Intega
Viewpoint - Stage E3
Humly, Bendigo

Street Landscape Plan 1

CITY OF GREATER BENDIGO LANDSCAPE PLANS

Drainage Reserve Landscape Plan

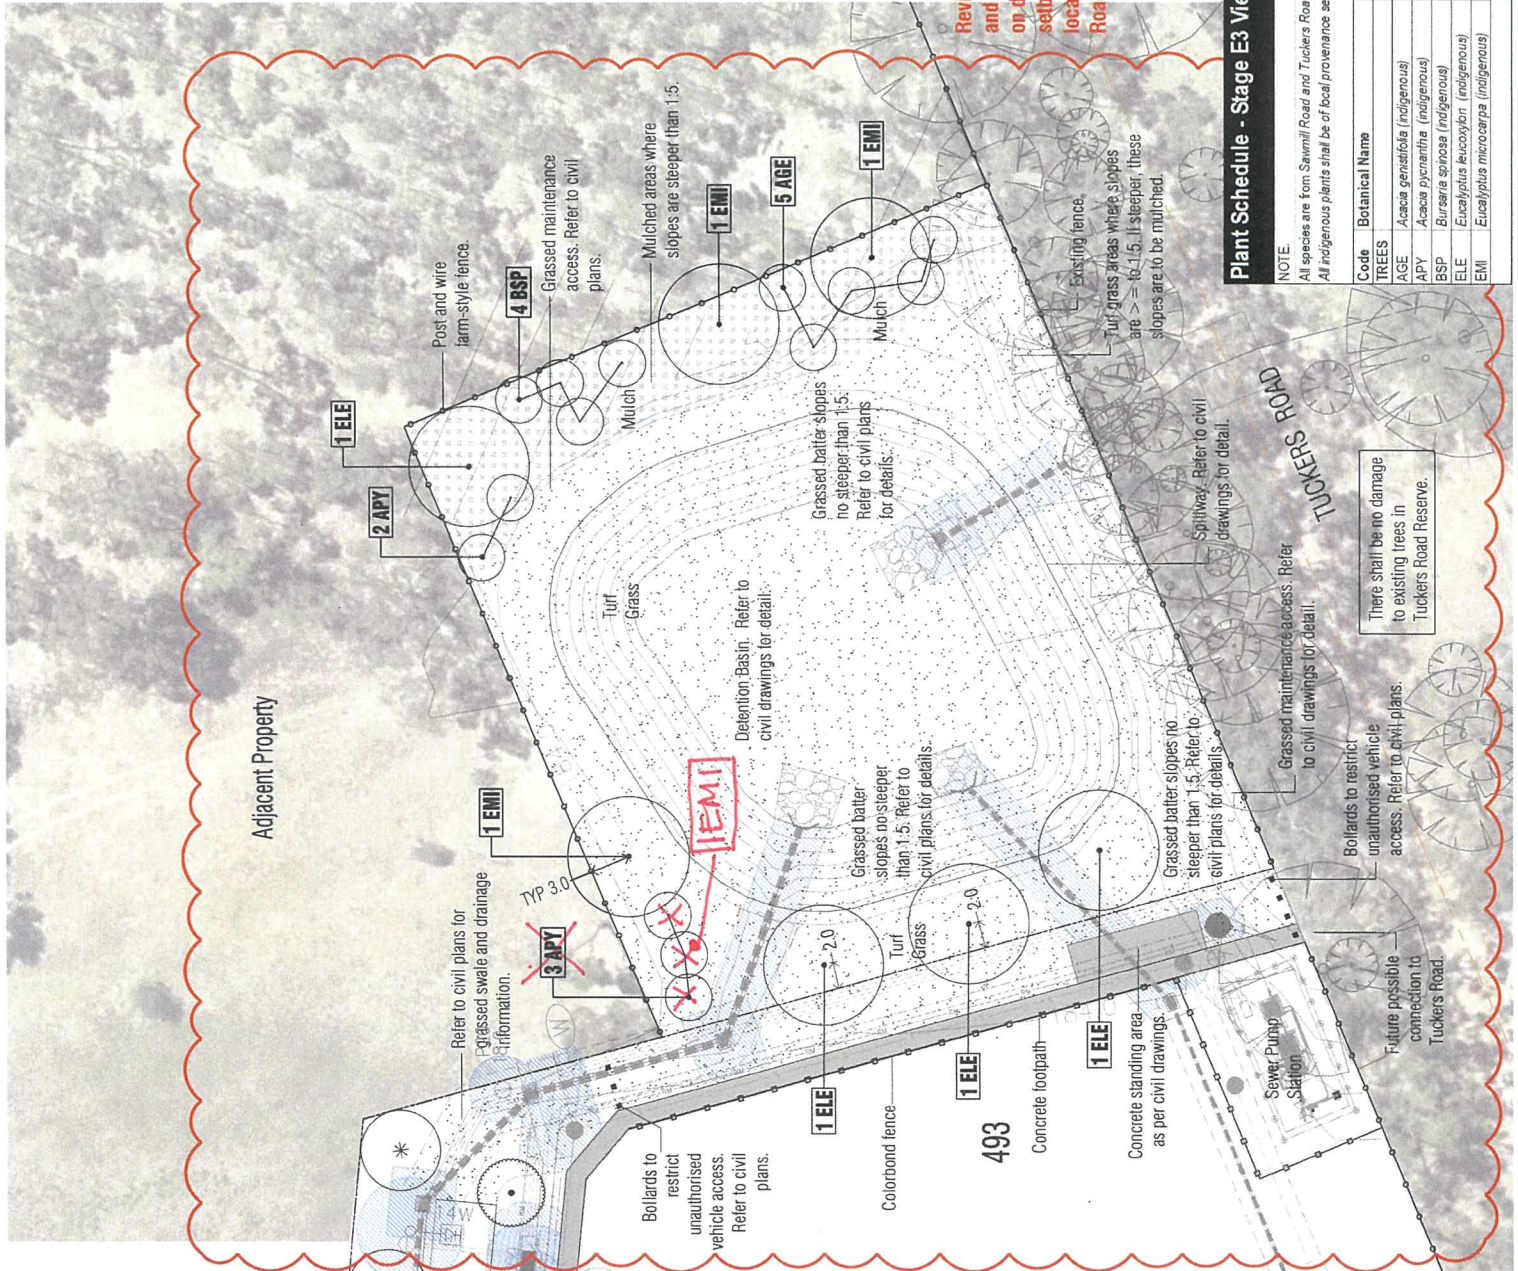
Revisions TP2: extent of grassed areas and mulched areas amended depending on design slopes; removal of gravel; setback of trees from fence 3.0m and location of existing trees in Tuckers Road Reserve.
